## Arlington Zoning Board of Appeals

##### **2. #3747 10 Sunnyside Avenue**

Reference Material	2023-06-13_10_Sunnyside_ZBA_Hearing_3_Presentation.pdf	ZBA Hearing 3 Presentation
Reference Material	Henderson_Letter_10_Sunnyside.pdf	Henderson_Letter 10 Sunnyside
Reference Material	2023-06-09_10_Sunnyside_Arlington_Civil_Set_Plan_Updates_-_Revised.pdf	2023-06-09_10 Sunnyside Arlington Civil Set Plan Updates - Revised
Reference Material	2023-06-13_10_Sunnyside_ZBA_Hearing_3_Presentation_-_Revised.pdf	2023-06-13_10 Sunnyside ZBA Hearing 3 Presentation - Revised
Reference Material	TertraTech_letter_to_Christian_Klein_-_Comprehensive_Permit_10_Sunnyside.pdf	TertraTech letter to Christian Klein -Comprehensive Permit 10 Sunnyside
Reference Material	10_Sunnyside_Revised_List_of_Requested_Waivers_7-2023.pdf	10 Sunnyside Revised List of Requested Waivers 7-2023
Reference Material	10_Sunnyside_-_Comprehensive_Permit_Peer_Review_Response_-_July_31_2023.pdf	10 Sunnyside - Comprehensive Permit Peer Review Response - July 31 2023

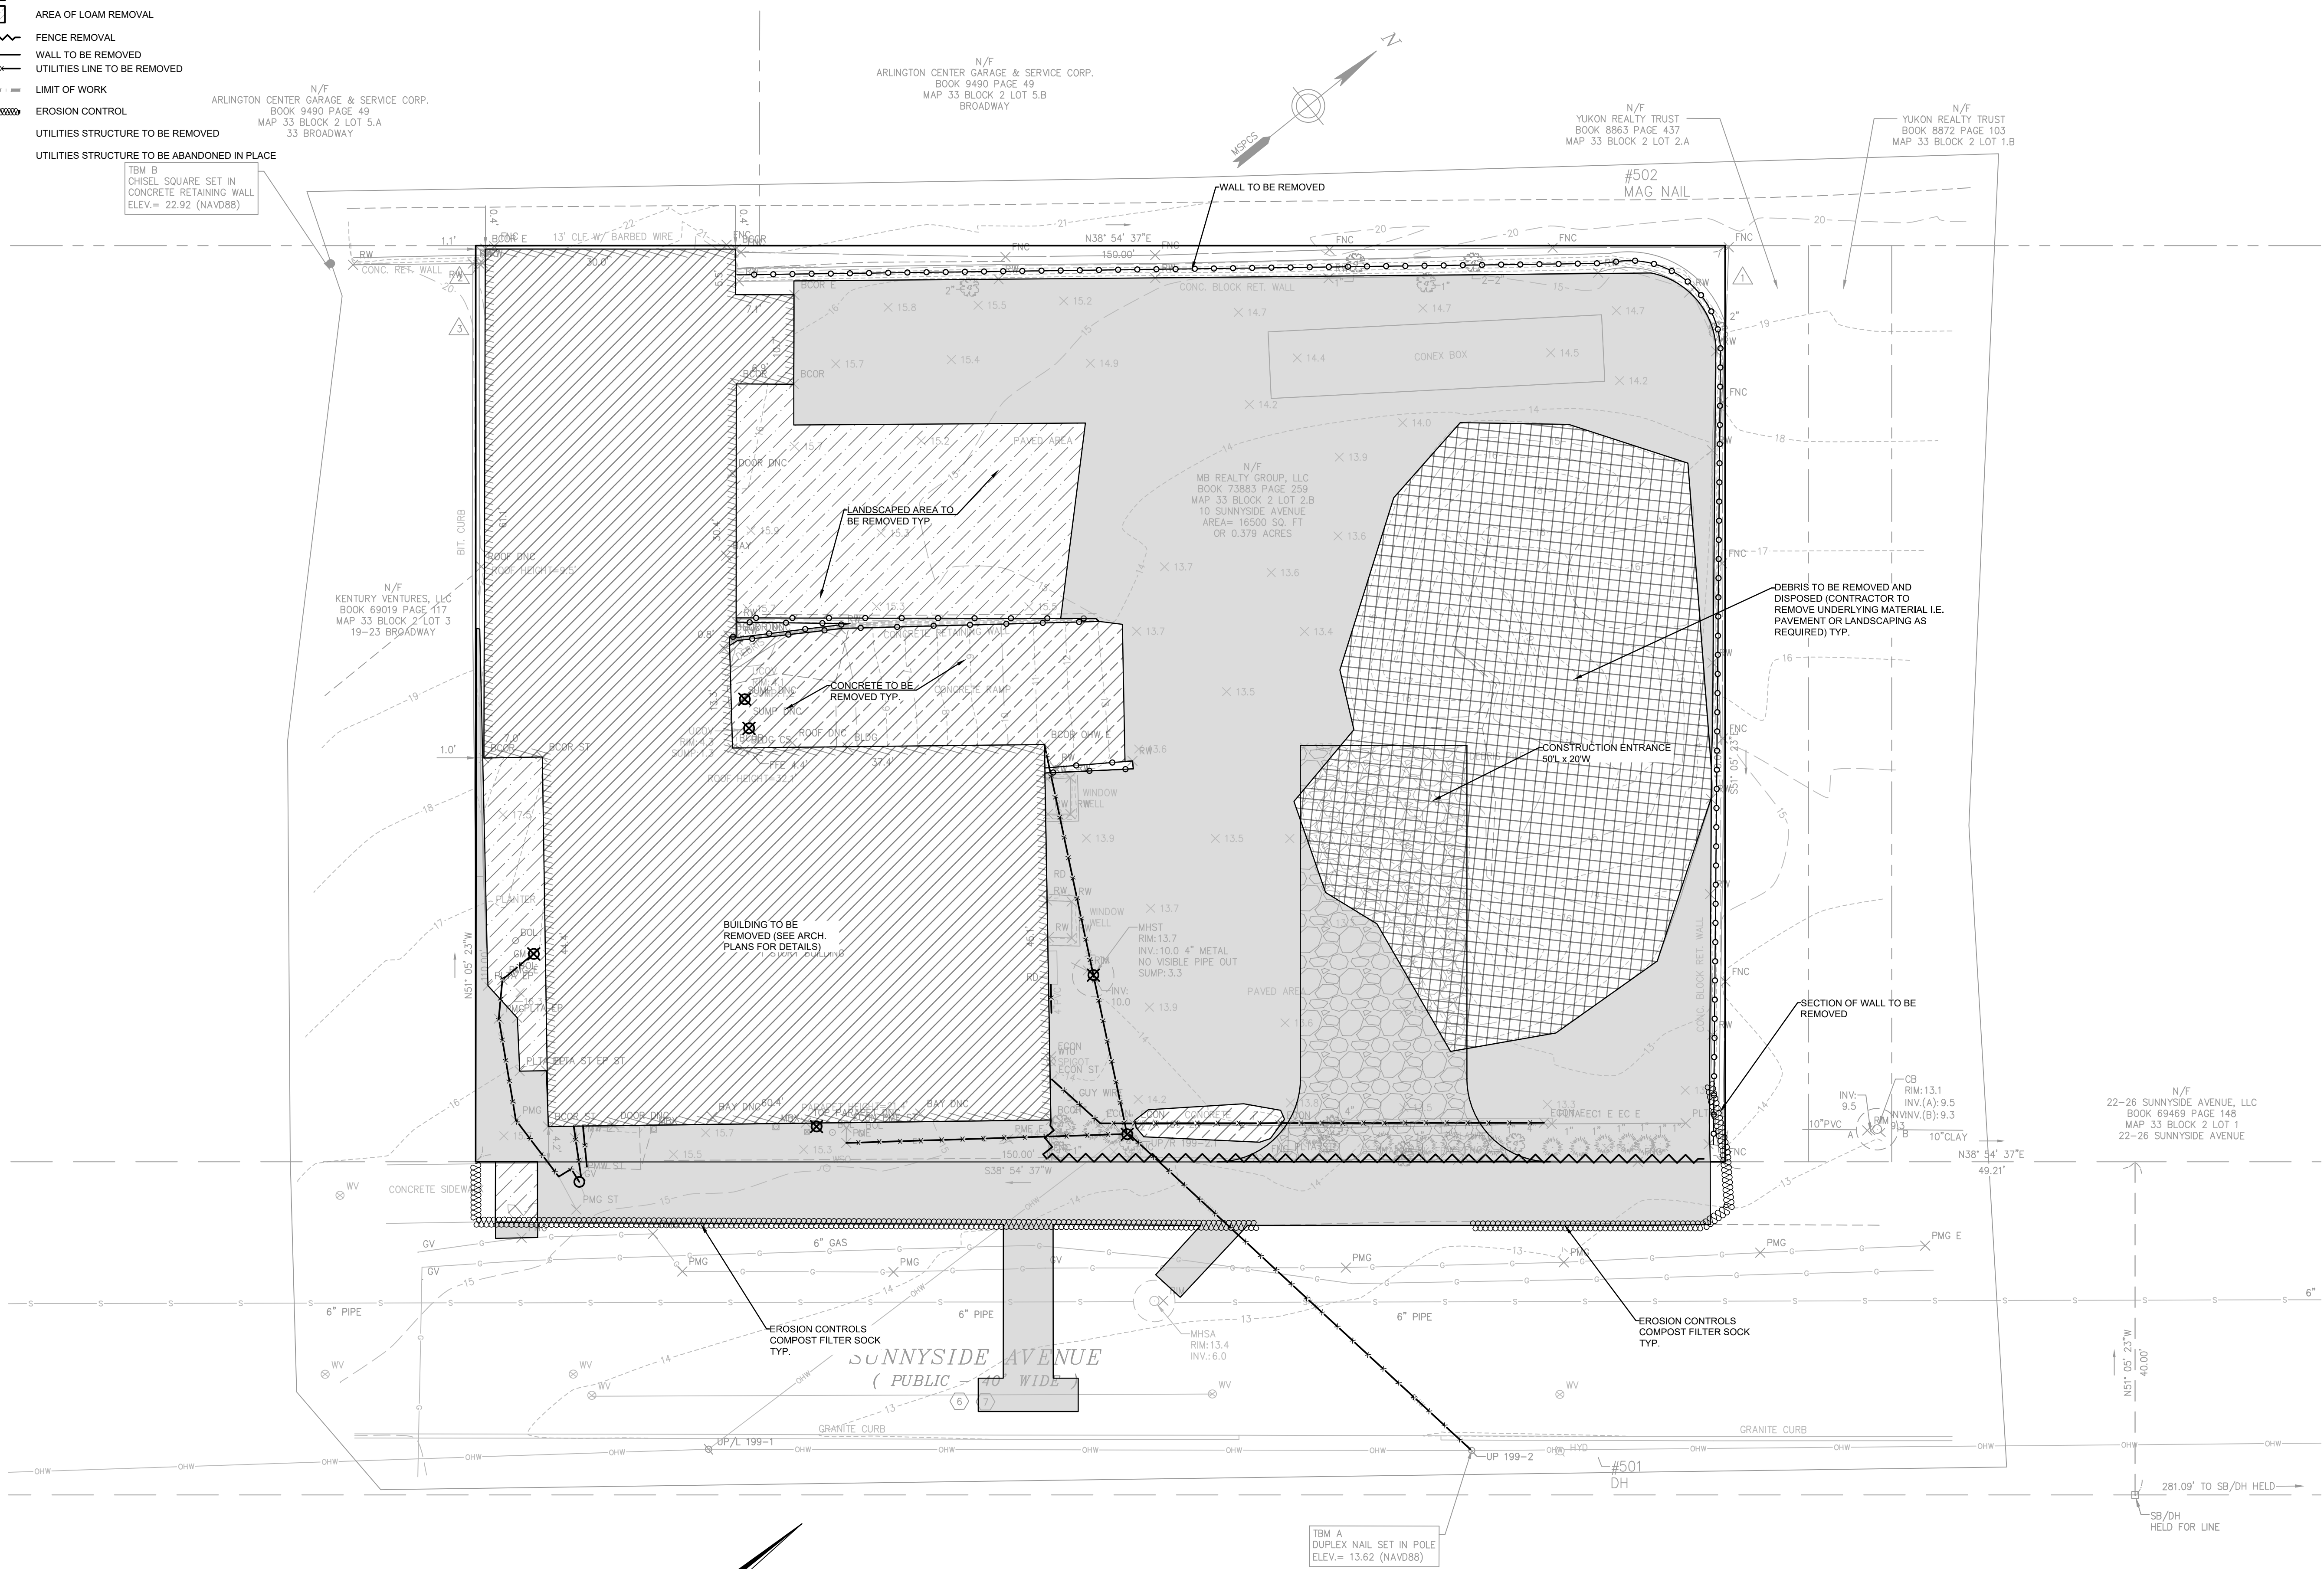
- Will PV panels be flat or raised ?

*Response: PV panels will be ballasted roof-mount system approximately 18" tall; they will not be visible from the street.*
